Re: National Fuel Gas Supply Corporation's Response to Amended Notice of Amendment; CPF 1-2026-020-NOA; Bennington and Holland UNGS

Bennington and Holland UNGS

CPF 1-2026-020-NOA

Diagram 1 – Configuration to apply a 25% pressure differential across the Master Valve (Pressure P2 25% less than pressure P1)

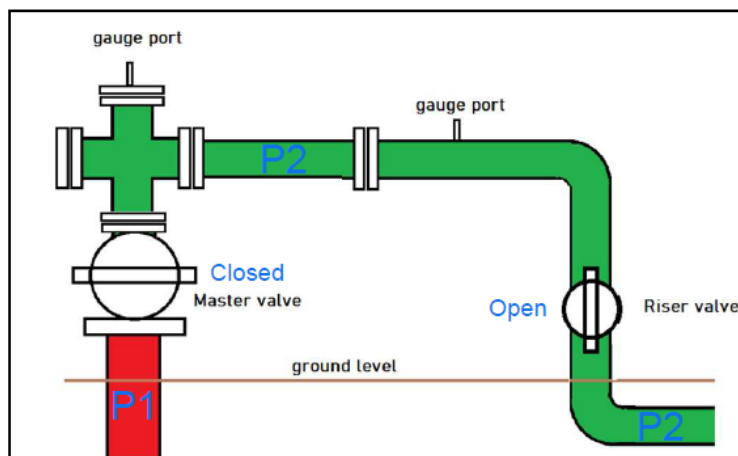
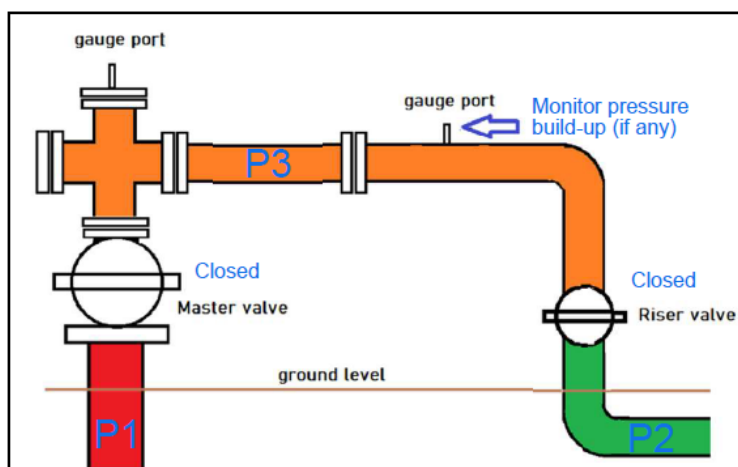
1. Records from the 2024 isolation tests for Wells 1550-I, 1533-I, 1462-I, and 1456-I demonstrate, in PHMSA's view, that National Fuel's then-current 75% threshold did not ensure well isolation.
2. A test permitting a pressure change of up to 75% constitutes a "leak allowance that obscures inadequate valves" rather than a demonstration of the ability to isolate the well.
3. National Fuel's valve maintenance program was insufficiently detailed because it did not establish specific written procedures for effective valve repair and replacement nor documentation standards for those activities.

In the NOA, PHMSA references National Fuel's *Storage Integrity Management Plan V. -2025.3* (7/29/2025) ("V. 2025.3") and notes that records for 2024 isolation test for Wells 1550-I, 1533-I, 1462-I, and 1456-I revealed that the results were not aligned with the 75% threshold in the procedures. National Fuel would like to [re]clarify that the 2024 testing and results were aligned with, and followed, the version of the Company procedure in place at the time the 2024 testing was conducted. The 75% actionable pressure recovery threshold, specified in V. 2025.3, was not yet in place.

National Fuel explained that as part of the March 3, 2025 revision to the STIMP, it established an actionable pressure recovery threshold of 75% (expressed as the percentage of pressure recovered, within the closed space downstream of the closed valve after 5 minutes following the application of a minimum 25% pressure differential across the valve sealing surface). This process is depicted in Diagram 1 and Diagram 2 below. That revision also required additional investigation when pressure recovery exceeded the threshold and required valves that did not pass repeat testing be placed on a risk-prioritized replacement list. In the same revision—and in the absence of a definition in API RP 1171—National Fuel defined valve isolation as "the ability for a valve to limit the flow of gas from the well to the pipeline system within a defined safety threshold."

- Defined the actionable pressure buildup threshold as pressure buildup downstream of the closed valve equal to or greater than 75% of the initial pressure differential imposed across the closed valve during the test (as calculated in accordance with the procedure) to trigger investigation and retesting. (Exhibit A)
